LFIA Riverside Committee

Presentation to The Land Use Committee February 25, 2020

Land Use - Transportation

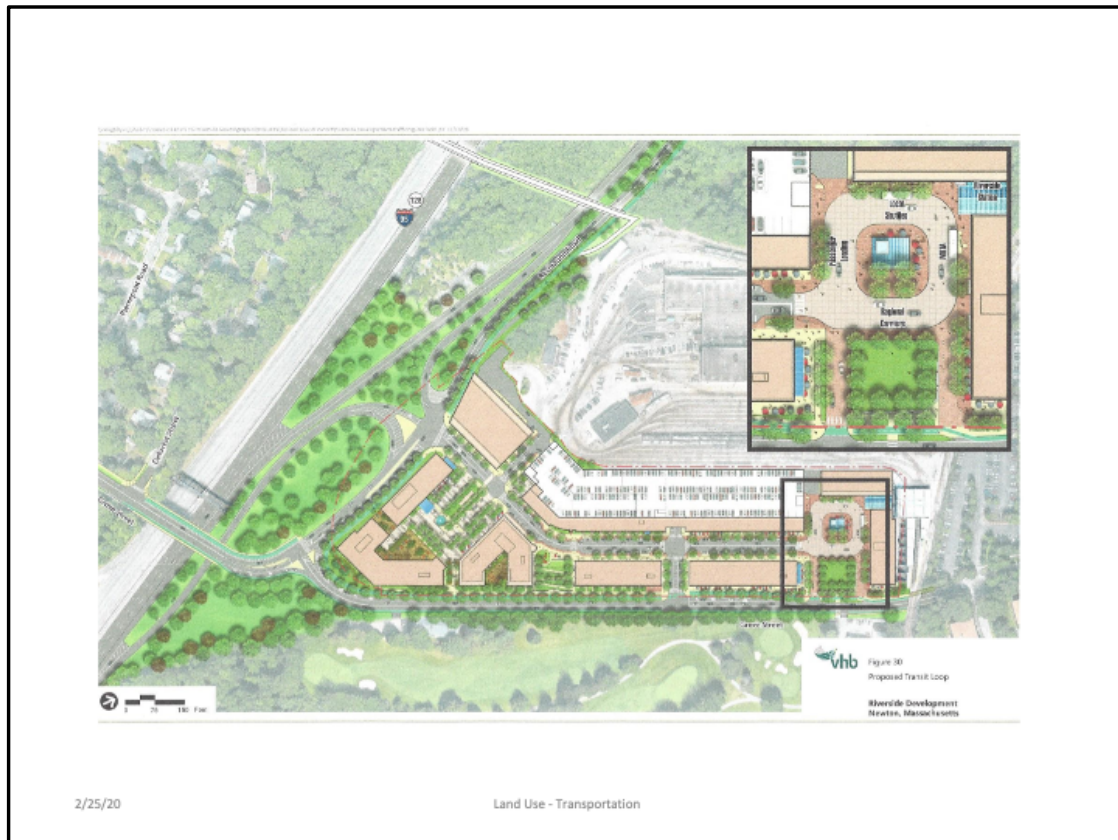
Rideshare companies like Uber and Lyft were **not** “counted” in the traffic study. They need to be.

In 2018 Newton had 1M rideshare trips, a 23% increase from the prior year.

Describe the transit square and transit green. MBTA emergency route, Bldg. 7 delivery corridor (back in, drive out), access to Bldg. 8 dock and Garage 9, bike shelter in the center.

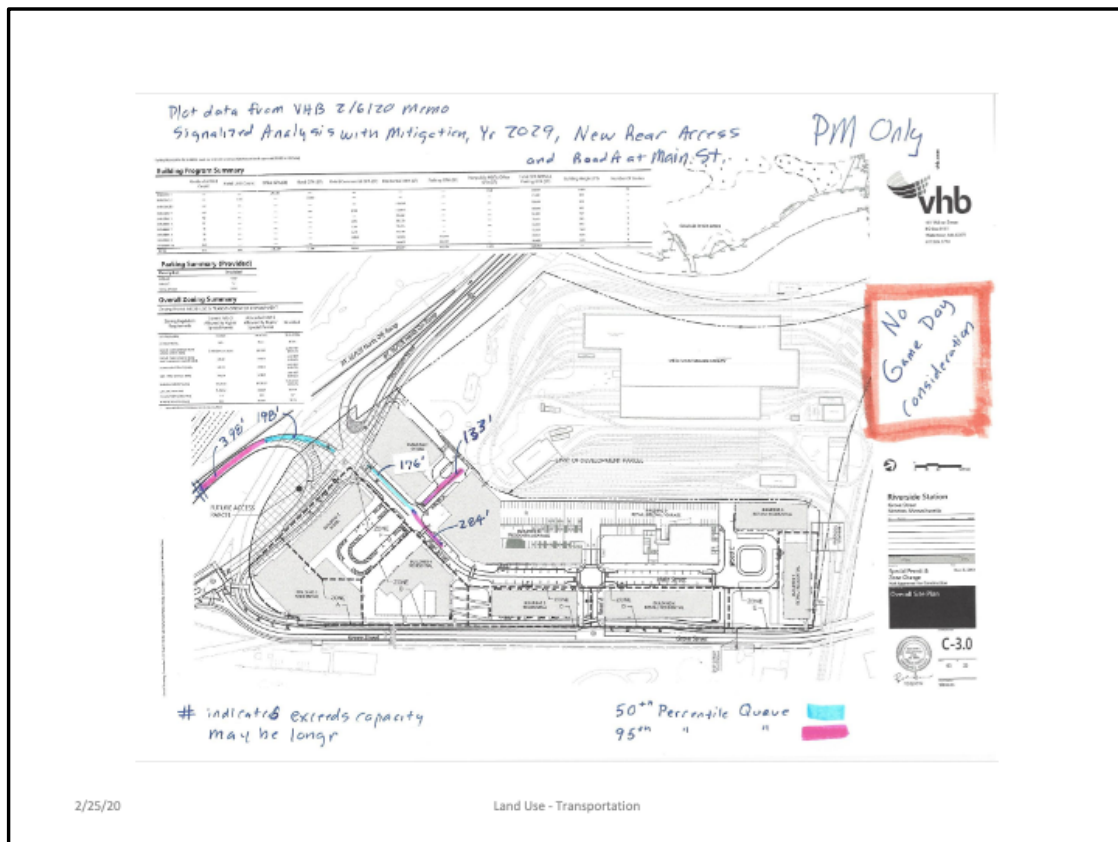
Deliveries and drop-off vehicles to Bldg. 4 will be passing through it; this was never the case at existing platform area.

I measured over 2400' of drop-off curbs at the existing site, only 500' in the transit square, but only about 200' are really usable. Almost a half mile today -- and 200' upon build-out.

Rest of the old site will now be flooded with activity and no longer available for transit use.

The bike shelter in the middle of the loop will add tension to vehicular travel. For safety reasons bikes and pedestrians should not be in the middle of the loop.

Traffic capacity analysis and simulation was not done here. MBTA and Developer need to redesign this part of the site. It is too important, it needs to be much bigger, especially for the future.

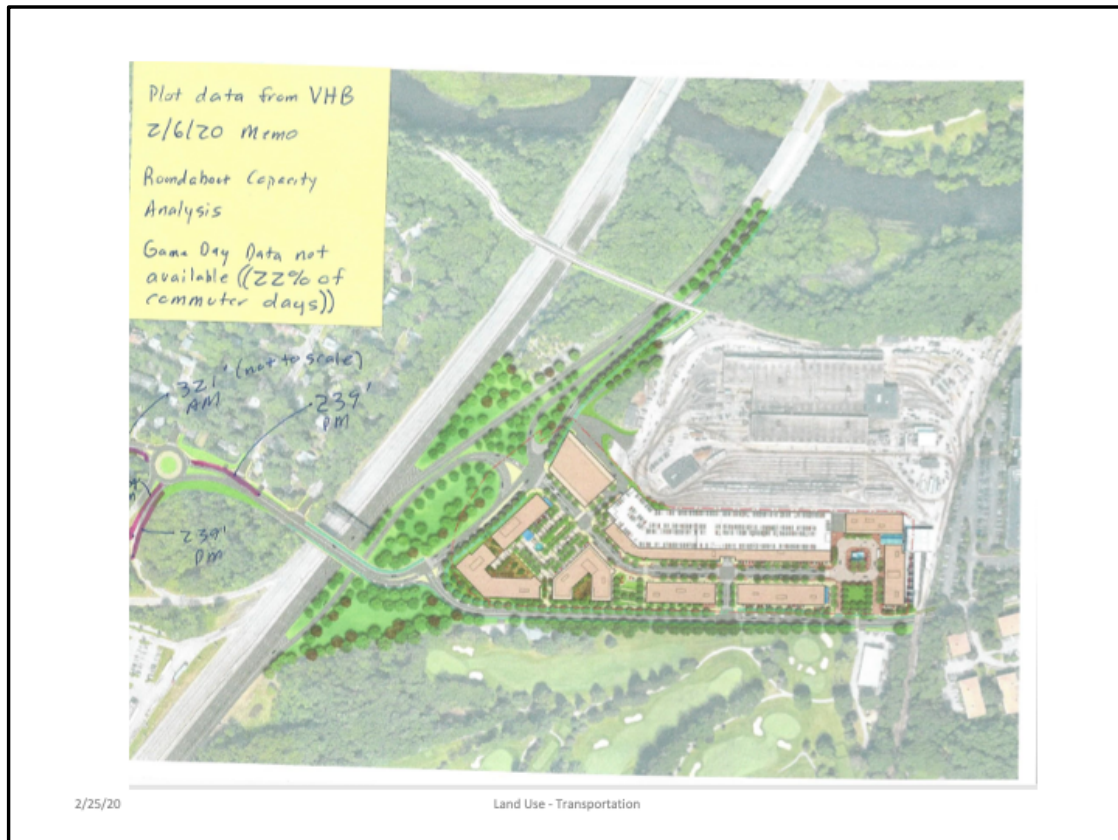
This evening rush hour queue, that I plotted, is bad news.

Signal priority exacerbates Main Street queue.

This queue doesn't accommodate game day conditions, which adds about 15% more traffic volume.

We all worked hard for the direct access ramp, but if folks can't use it in the evening, they will instead flood Grove Street. This is not acceptable. The site plan needs to be revisited so the traffic flows through there.

MBTA Shortfalls (Need Documentation!)

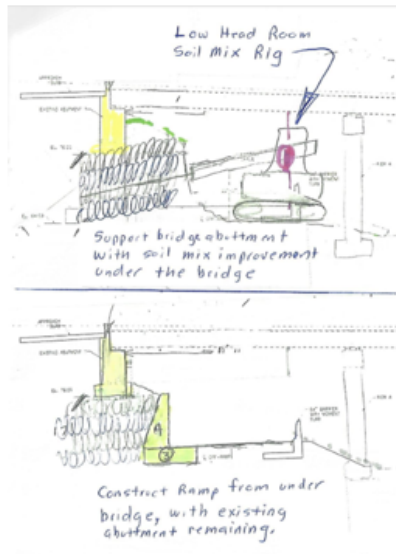
Read 2 bullets, then: Developer estimates T parking will be limited to 400 spots during the initial construction phase. They intend to construct the garage and many other building at the same time. Commuters losing 560 spots are being treated unfairly.

MBTA and Newton should stick to the Riverside 1 staging: Garage completed before anything else can happen.

MASSDOT Issue Under Grove St. Bridge

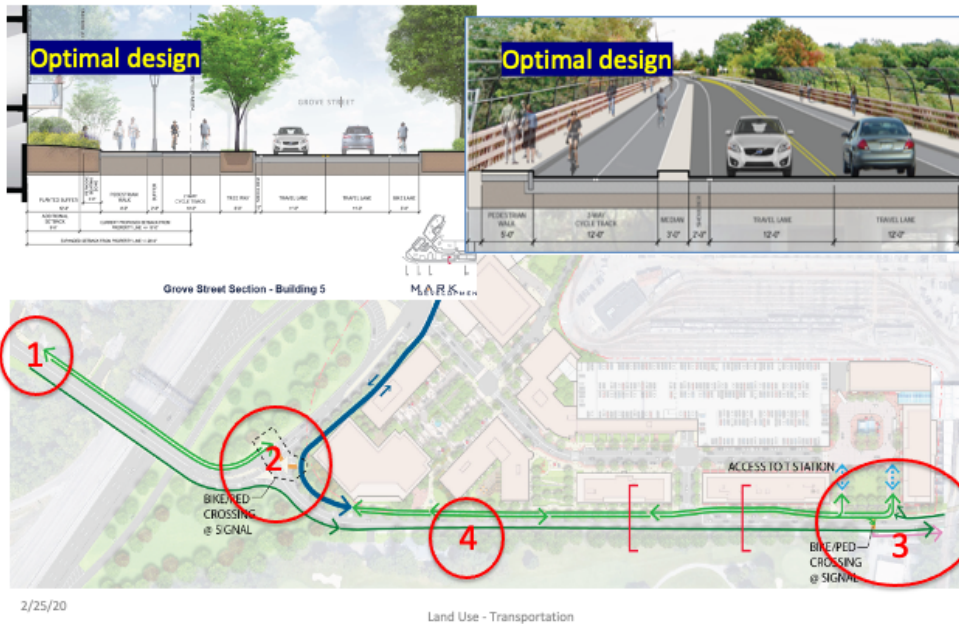
We favor: New access ramp from 128 northbound that passes under the Grove Street bridge in the sloped section under the existing yellow abutment.

If we use standard construction methods (replacing half of the bridge at a time, squeezing Grove Street traffic onto the other half), it could triple the time required and cost.

Constructing the new ramp entirely from below the Grove Street bridge is much more sustainable. It is cleaner, quicker, generates a lot less noise, and is a lot safer for workers and the public.

Bike Ped Crossing at MBTA underpass dangerous
Transition to **no bike infrastructure** beyond
underpass a concern – needs careful thought

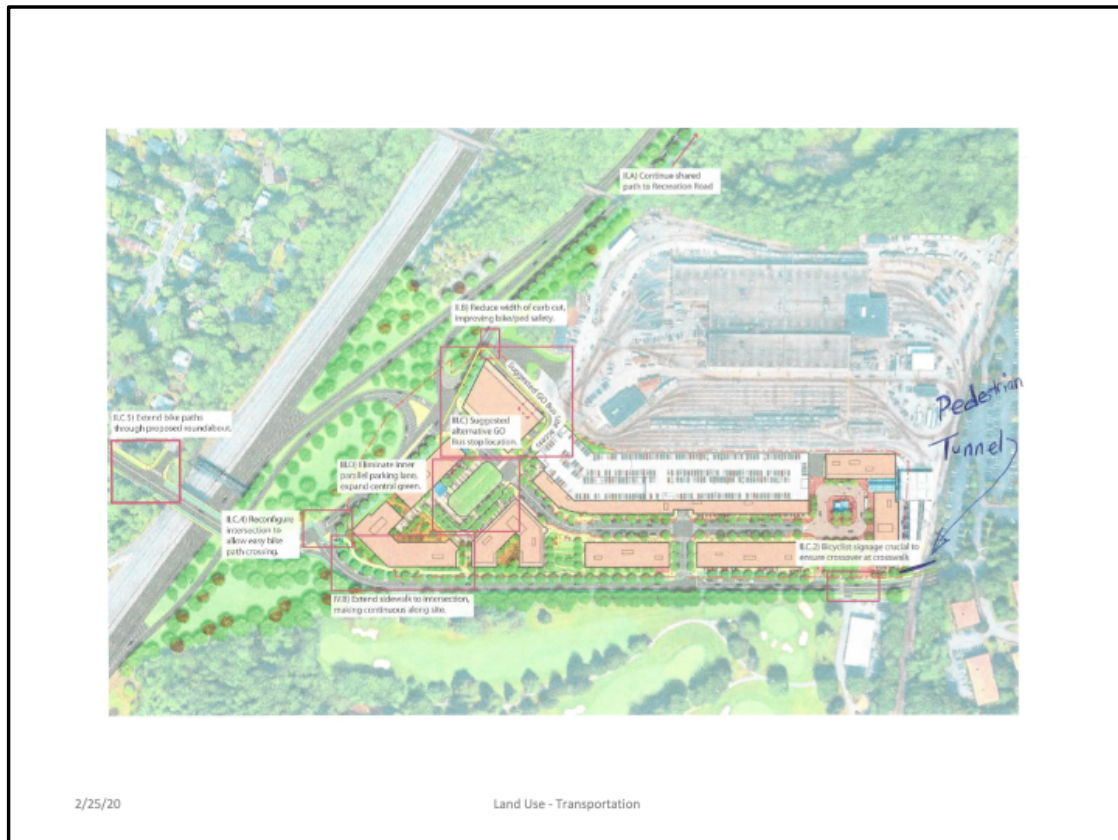
The pedestrian crossing here has a very dangerous vehicular sight line;

Williams and Lasell students may not survive it.

Also, the geometry of the bike paths and sidewalks is funneled under the Green Line bridge. It needs to be reworked. Our ideas follow.

We recommend eliminating the pedestrian crossing, since the third bike lane is redundant, and force all bike and pedestrian crossings to occur to the north just on the other side of the MBTA bridge.
